## X-TYPE

XT501-09

# TECHNICAL BULLETIN

Loss Of Headlamp Washer Jet Cover – Poor Retention – Install Pre-painted Covers/Revised Link MODEL 2002-03 MY X-TYPE

**ILLUSTRATION 1**

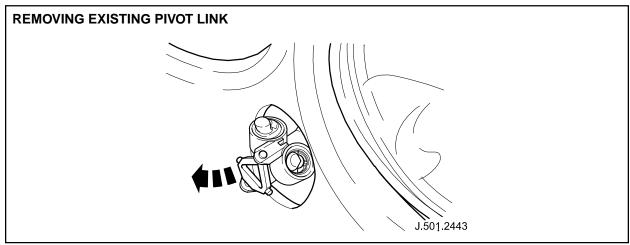
- 2. Displace and remove headlamp powerwash jet cover from link if installed.
- 3. Displace and remove headlamp powerwash jet cover link from headlamp powerwash jet (Illustration 1).

**ILLUSTRATION 2**

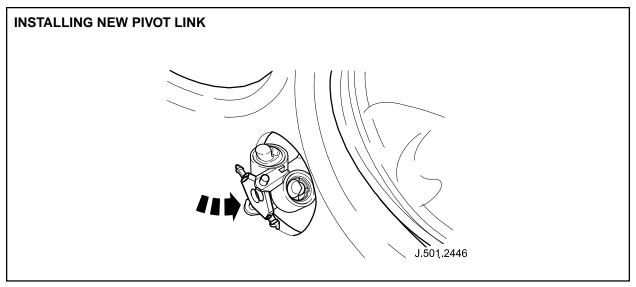
4. Install and seat new link to headlamp powerwash jet (Illustration 2).

**Note:** New link pegs are offset lowermost when installed for correct seating of cover to bumper.

**ILLUSTRATION 3**

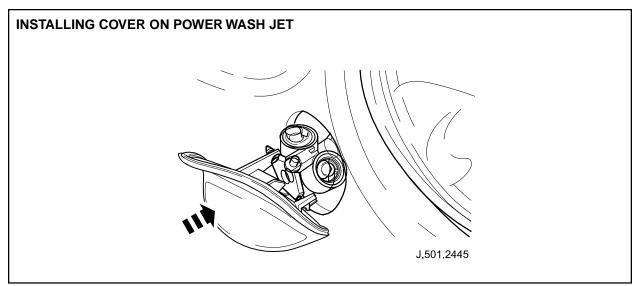
5. Install new cover assembly to new link (Illustration 3).

**Note:** Powerwash jet covers are marked on the rear face left hand or right hand.
